A	INSTALL RESTRICED RIGHT LANE SIGNS	
7-14-08	SHA NO.: AT0095185	
JKS

MARYLAND DOT - STATE HIGHWAY ADMINISTRATION
Office of Traffic & Safety
TRAFFIC ENGINEERING DESIGN DIVISION
(Traffic Signal Plan)

MD 528 (Coastal Hwy) at 67th Street

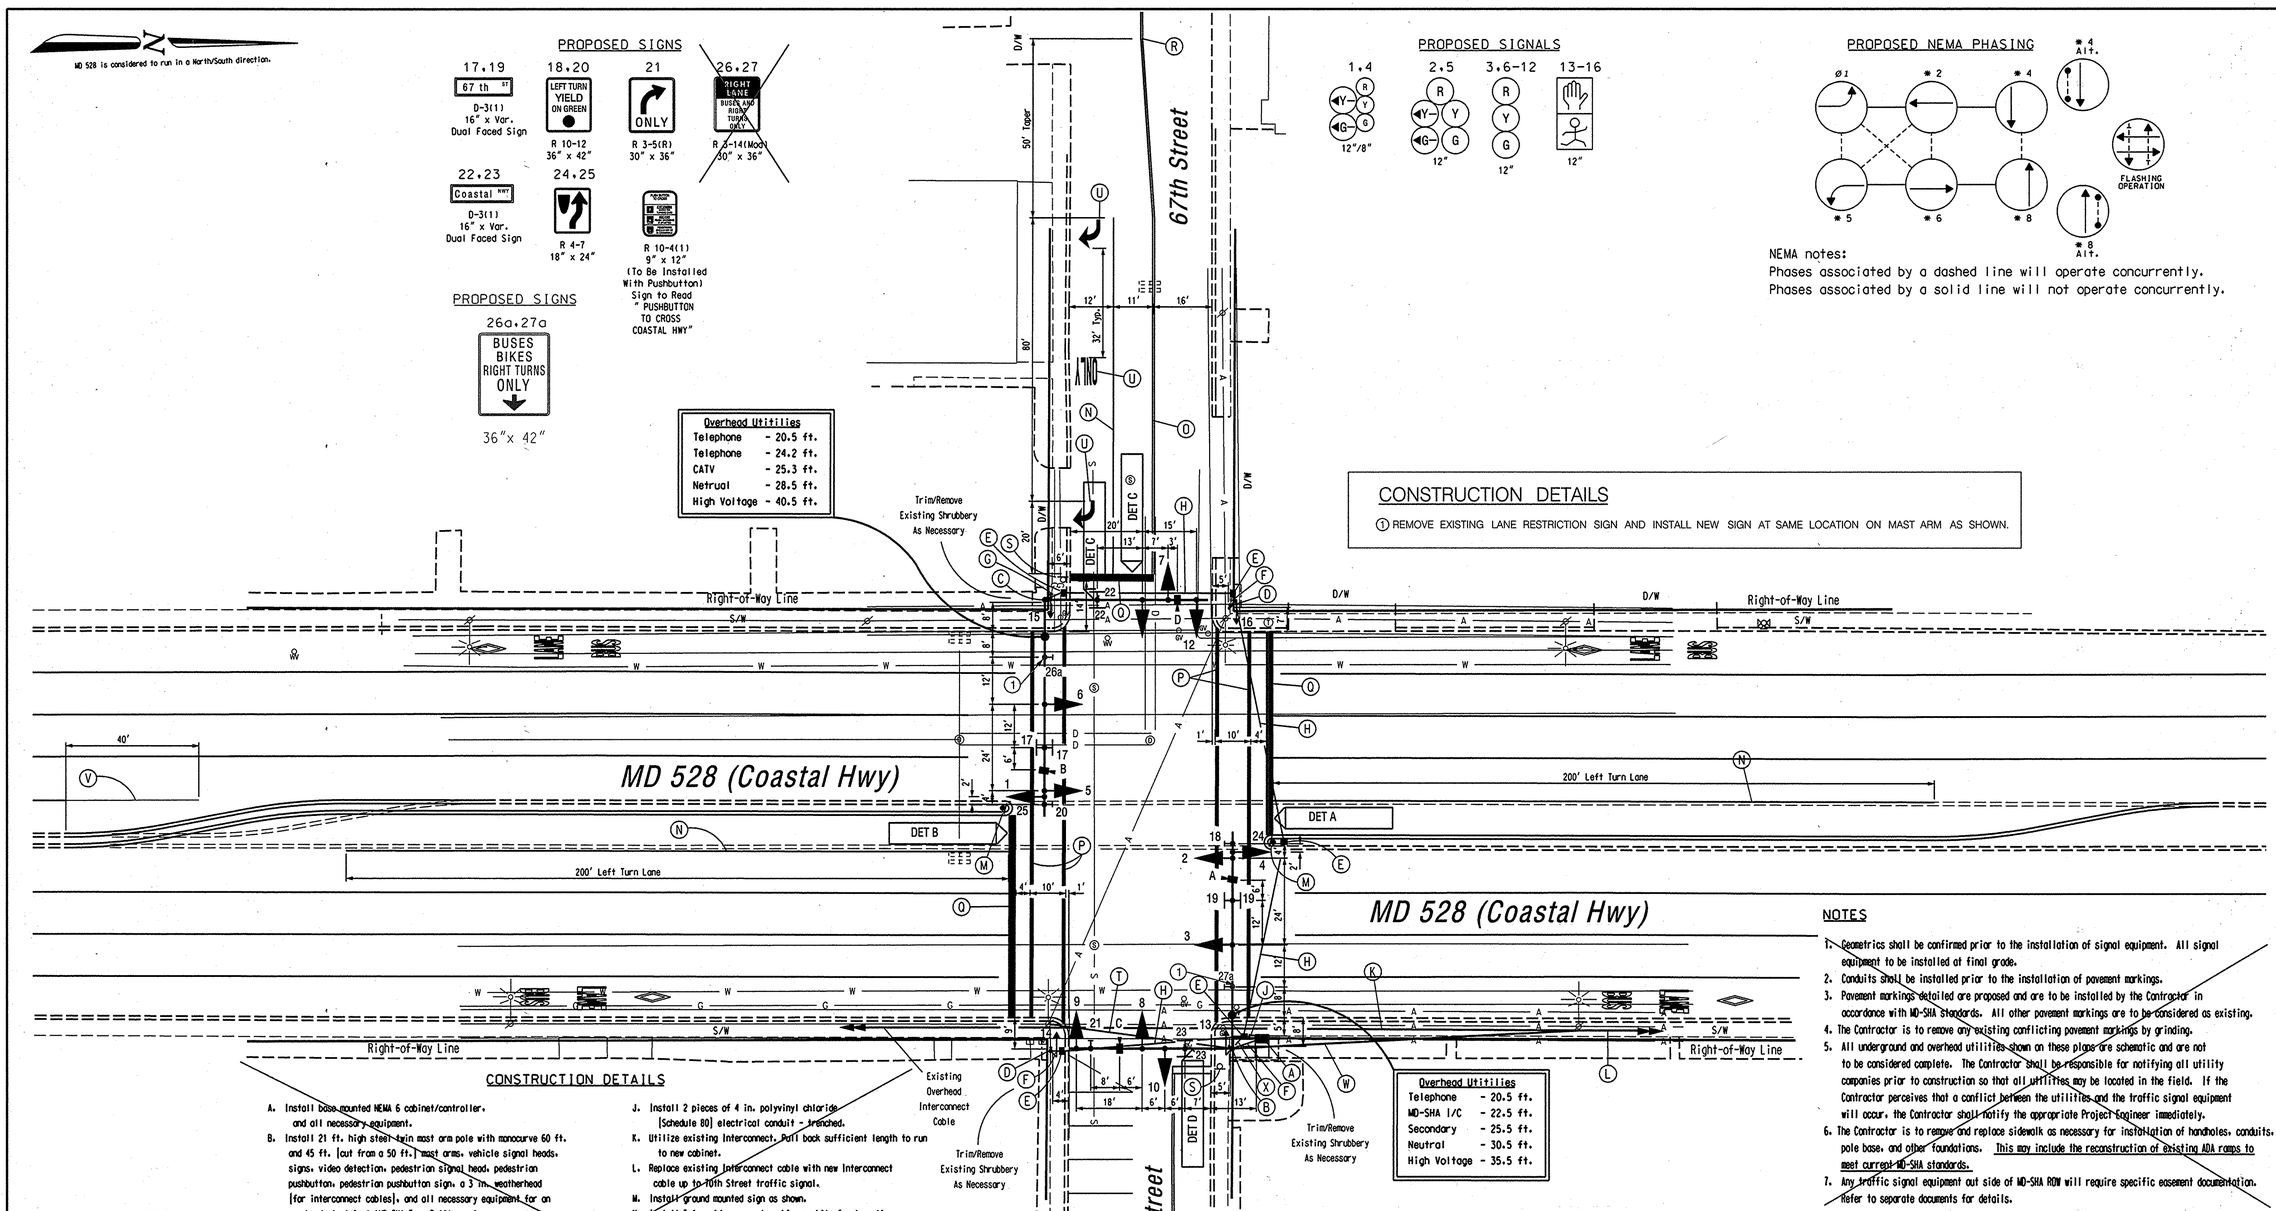
26,27 — ~~RIGHT LANE BUSES AND RIGHT TURNS ONLY~~ — ~~R 3-14(Mod) 30" x 36"~~

① REMOVE EXISTING LANE RESTRICTION SIGN AND INSTALL NEW SIGN AT SAME LOCATION ON MAST ARM AS SHOWN.

26a,27a — BUSES BIKES RIGHT TURNS ONLY — 36"x 42"
